Addendum No. 1

Subject: Franklin S. Edmonds Elementary School Major HVAC Renovation

This Addendum, dated June 10, 2021, shall modify and become part of the Bid Documents. Any items not mentioned herein, or affected by, shall remain strictly in accordance with the original document, as modified by addenda, if any.

DRAWING SCALE
**ARCHITECTURAL NEW WORK
BASEMENT FLOOR PLAN**

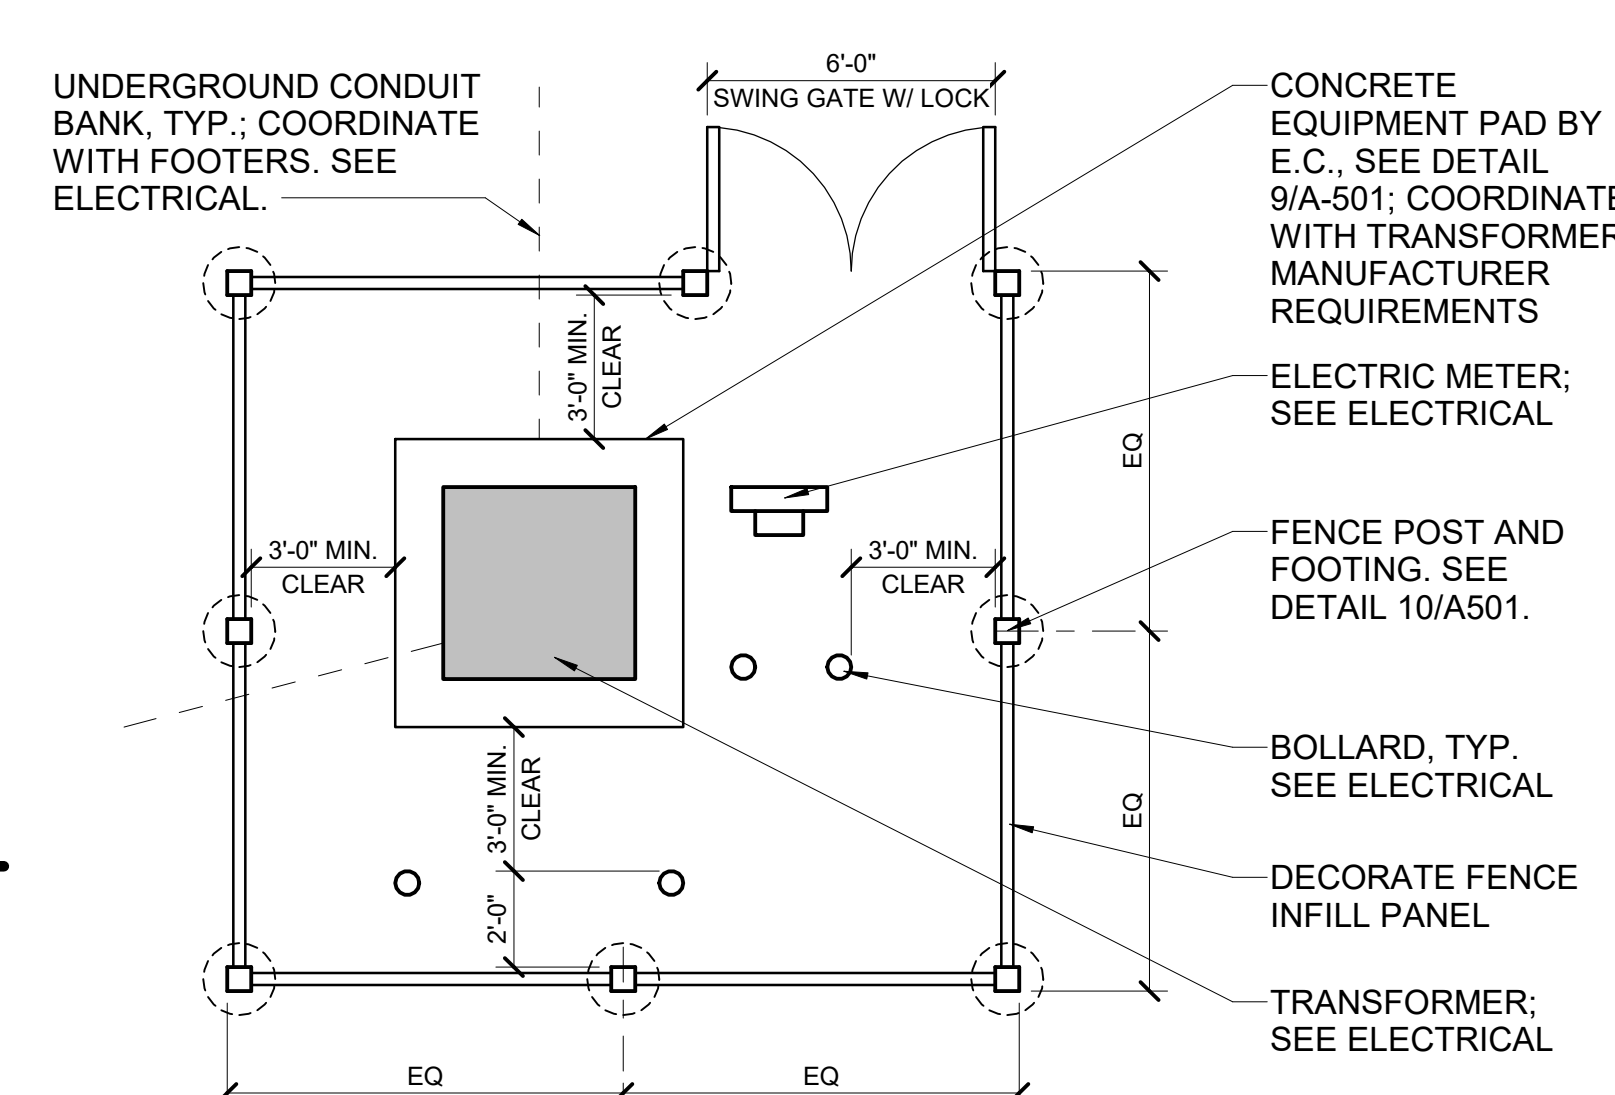
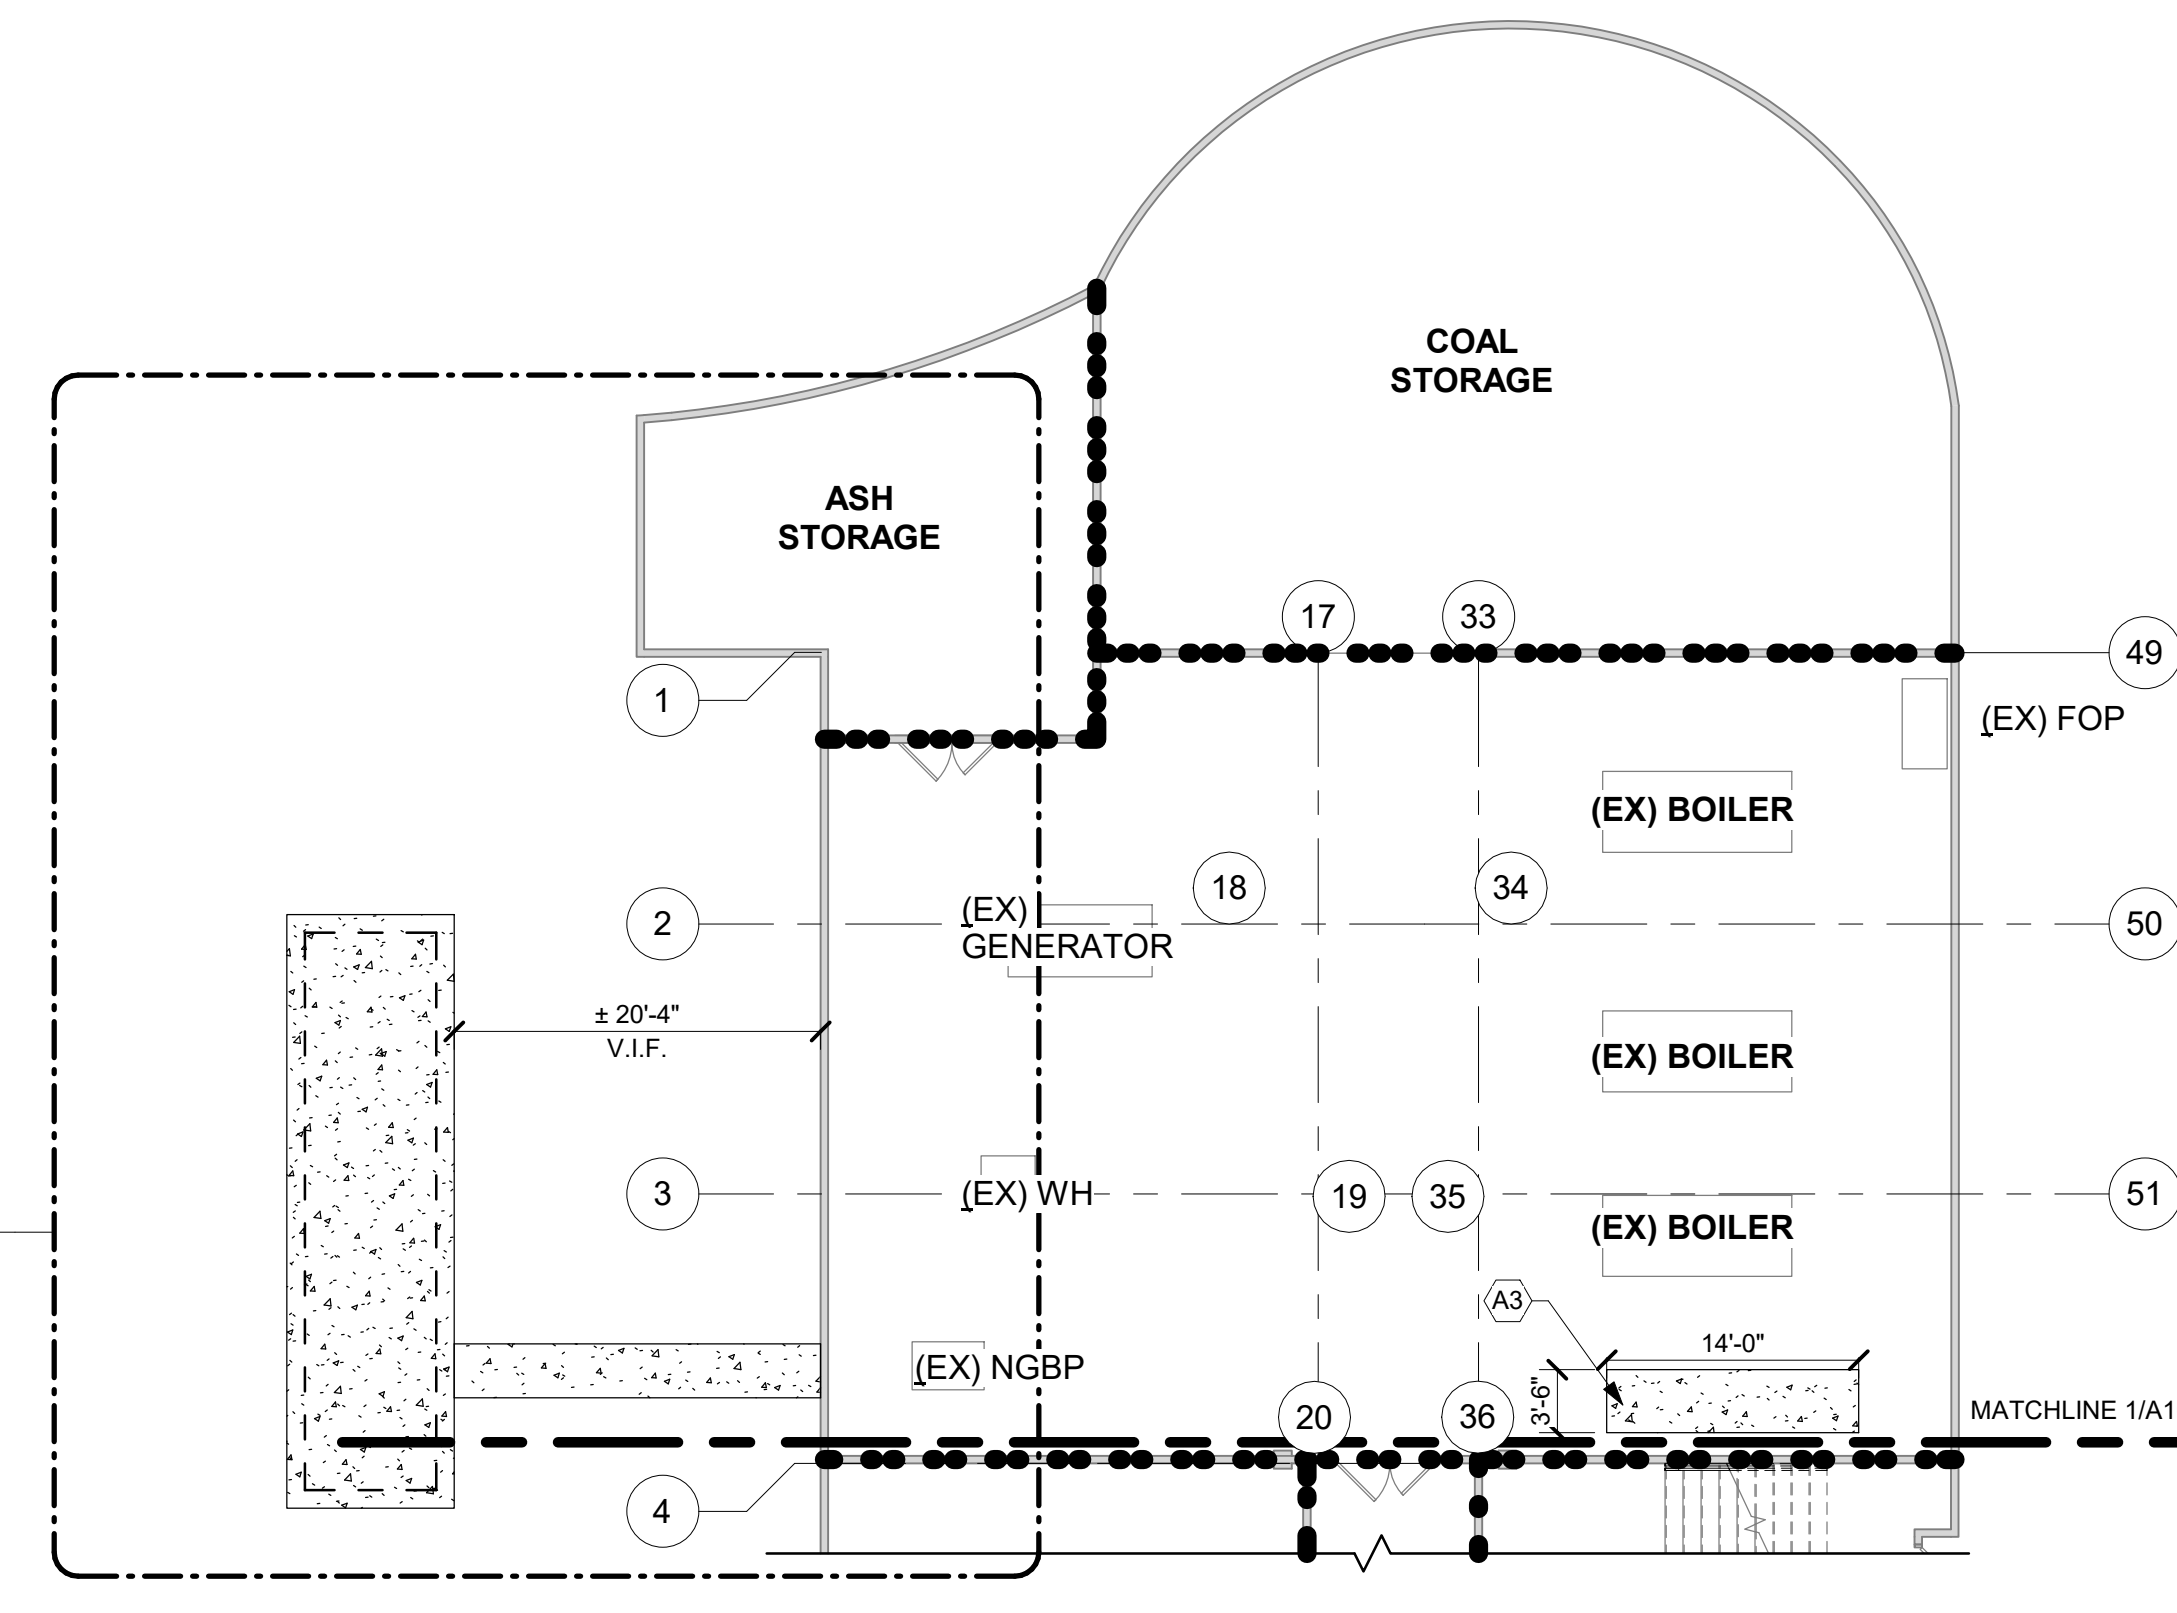
9. **ADD** *Keynote #4* to CUH-107 on E-202.
10. **ADD** *Keynote #A16* to A-101 in Room 9: “Provide five (5) equipment pads for the new electrical service equipment. Coordinate exact sizes and locations with electrical contractor.

- a. T1, T2, T5, T6, and CBs: approximately 4’-0” W x 10’-4” L x 0’-6” H
 - b. T3: approximately 2’-0” W x 2’-0” L x 0’-6” H
 - c. T7: approximately 4’-4” W x 3’-6” L x 0’-6” H

- d. T4: approximately 2’-0” W x 2’-0” L x 0’-6” H
 - e. SWBD-CH: approximately 6’-0” W x 3’-0” L x 0’-6” H
11. **MODIFY** EP-502 One Line Diagram New Main Distribution Panel MDP to indicate 1200A Capacity.

The General Contractor will provide five (5) new housekeeping pads for the electrical service equipment. See Drawing Modification #10 below.

4 ENLARGED PLAN - EXTERIOR TRANSFORMER

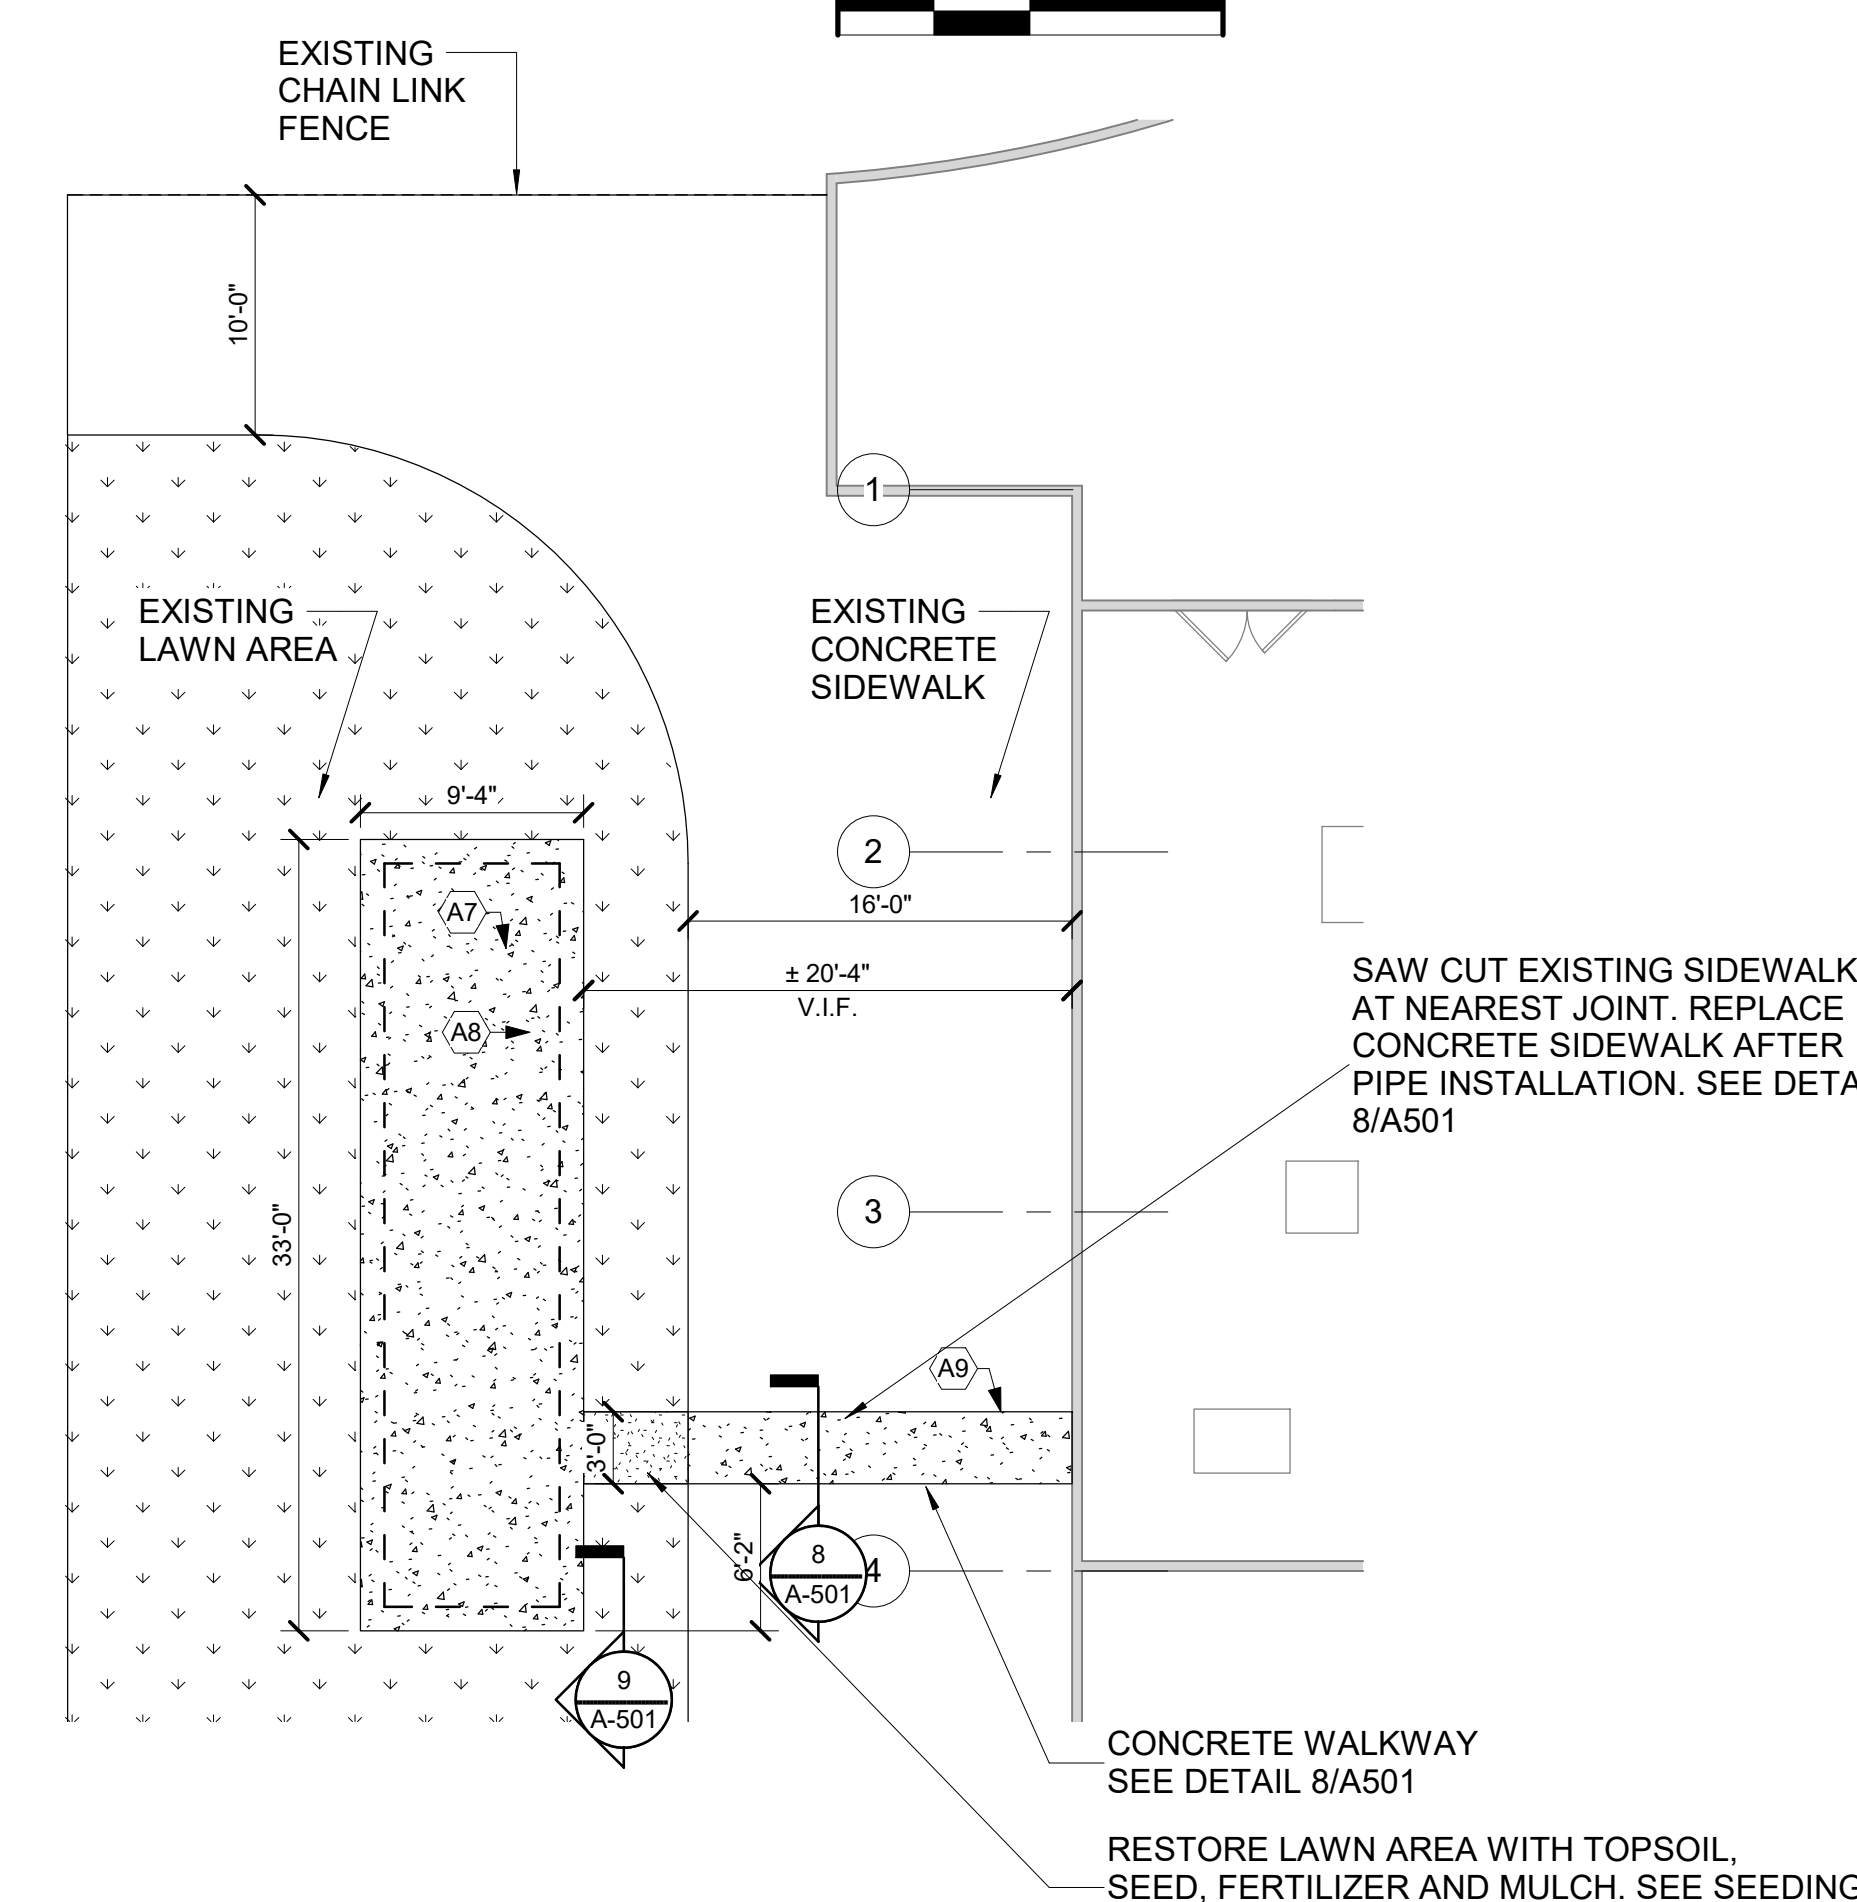
Please provide a spec and details for the fencing at the transformer.

12. **MODIFY** EP-101 *Keynote #11* to indicate: “Provide 6” high concrete equipment pad. General Contractor will provide new fencing, gate, planting, and re-seeding of area. Refer to A-101 for General Contractor scope of work”.

General Contractor is responsible for furnishing and installing (providing) a new fence, new plantings, and grass re-seeding per revised A-101.

Refer to attached updated drawings, as well as 4/A-101 for the plan and 10/A-501 for the footing detail.

3 TYP. FENCE ELEVATION

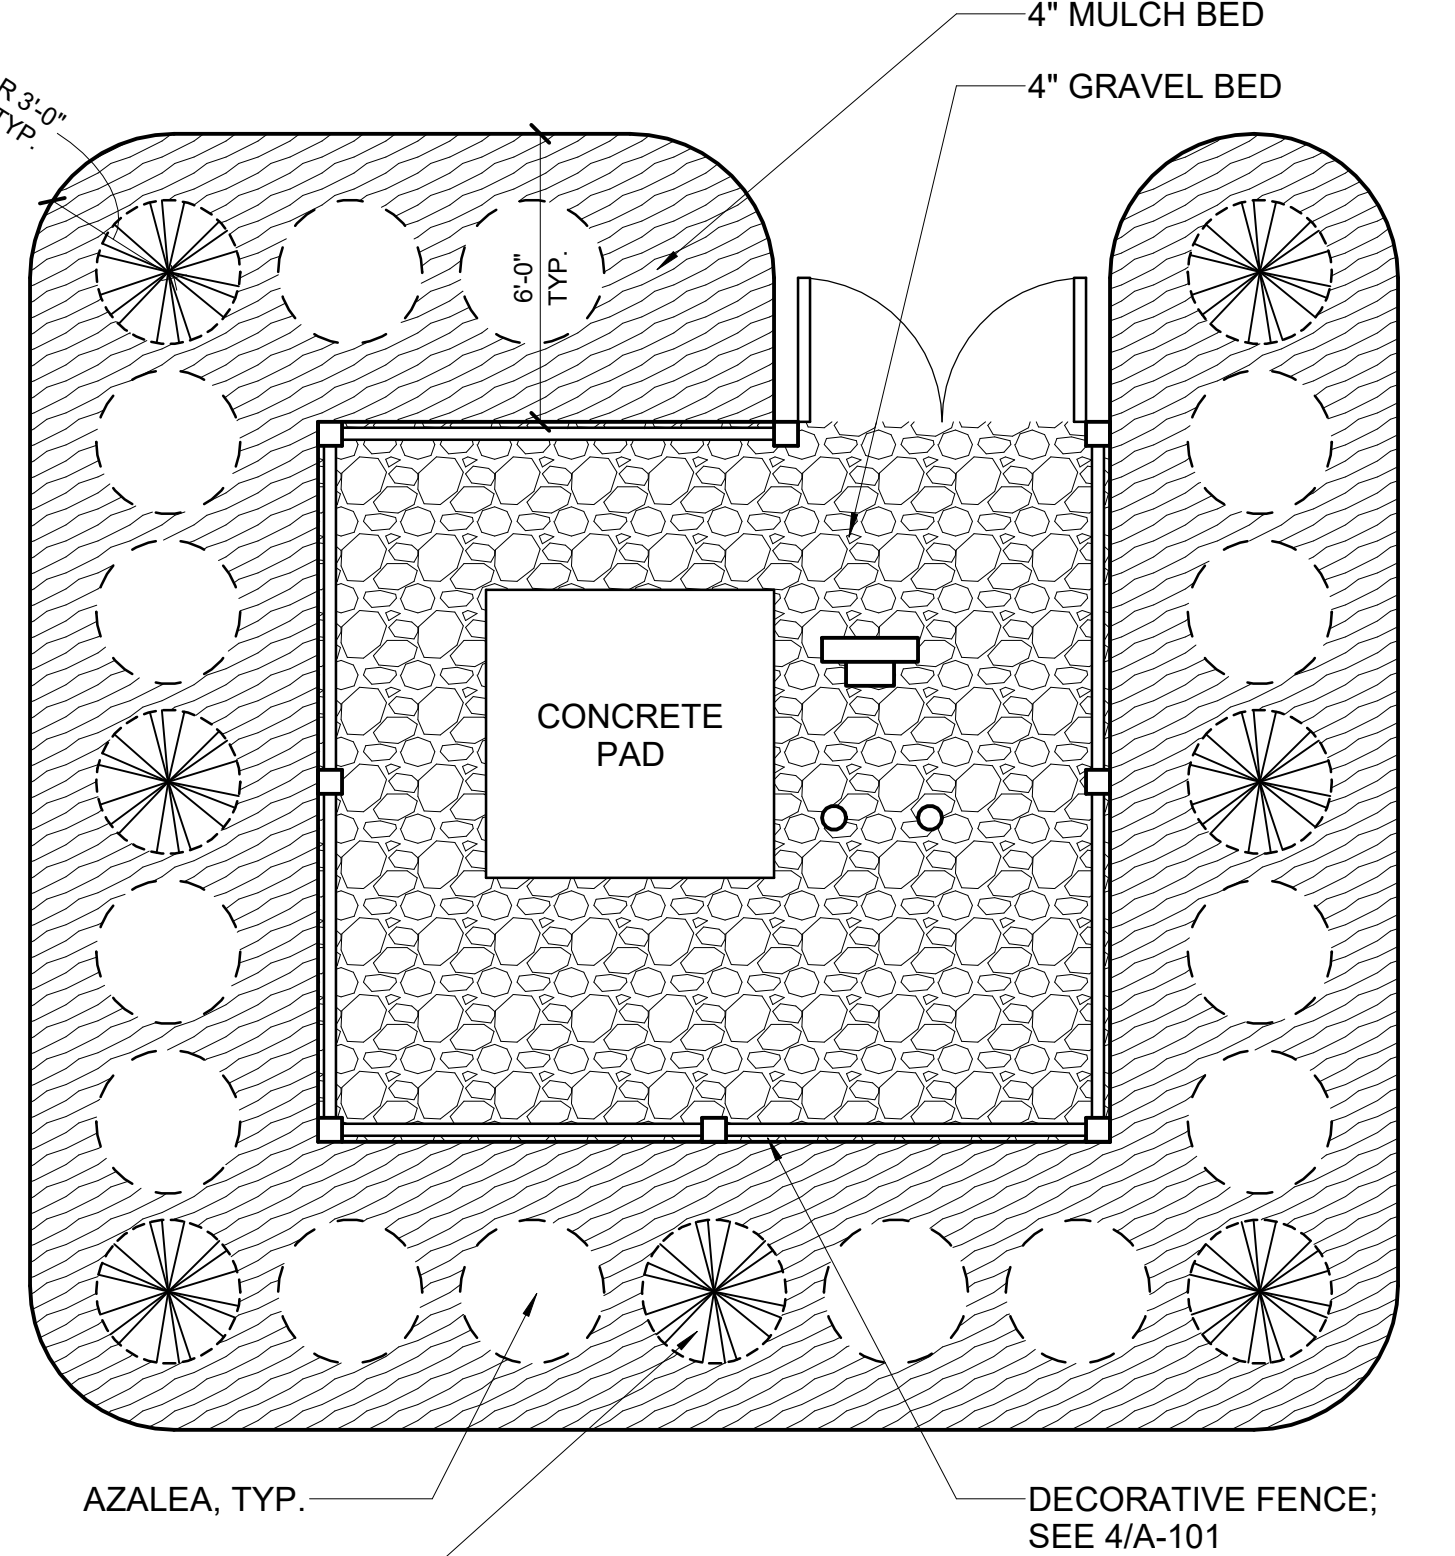
16. **ADD** Typ. Fence Elevation and Landscaping Plan to A-501. See attached.
